Service Bulletin

MARCH

NO. 322

Studebaker and Packard Clipper

FIG. 3

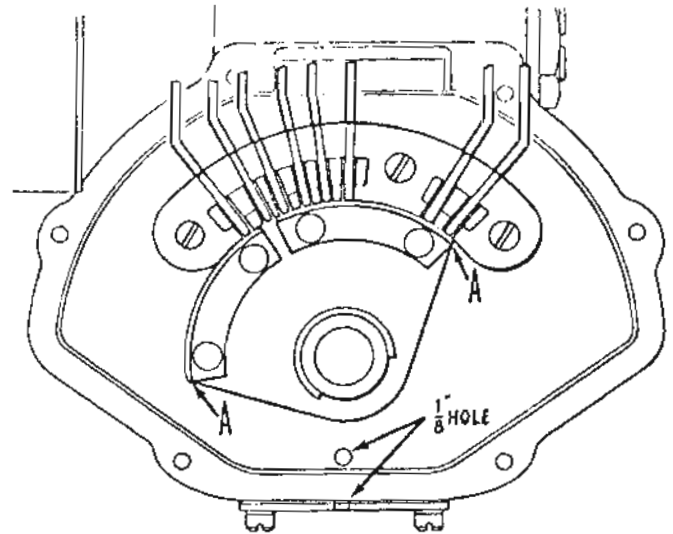
Under certain conditions condensation may accumulate in the actuator unit of push button control and cause corrosion of the contacts; also, an accumulation of transmission oil in the unit, if leakage occurs at the manual valve lever shaft seal.

To provide ventilation so that condensation is held to a minimum and in the event of a leak at the seal so that the oil may drain, we suggest that you make the following modification.

Drill a 1/8" hole at the center lower inner edge of the base plate to provide a vent into the lower main housing and another 1/8" hole in the inspection plate and gasket to provide a vent and drain from the main housing. Fig. 3 illustrates the approximate locations of the holes.

To prevent this interference when a over-travel occurs, round-off or chamfer the two corners (A, Fig. 3) of the contact segment.

This modification will also reduce the tendency of the transmission oil to seep past the seal. Therefore, it is recommended if the actuator is removed for any reason that the modification be made. Obviously, if a condition of oil in the actuator is encountered, also replace the seal.

This should be done when the segment is removed for any reason and the unit involved has sharp edges.
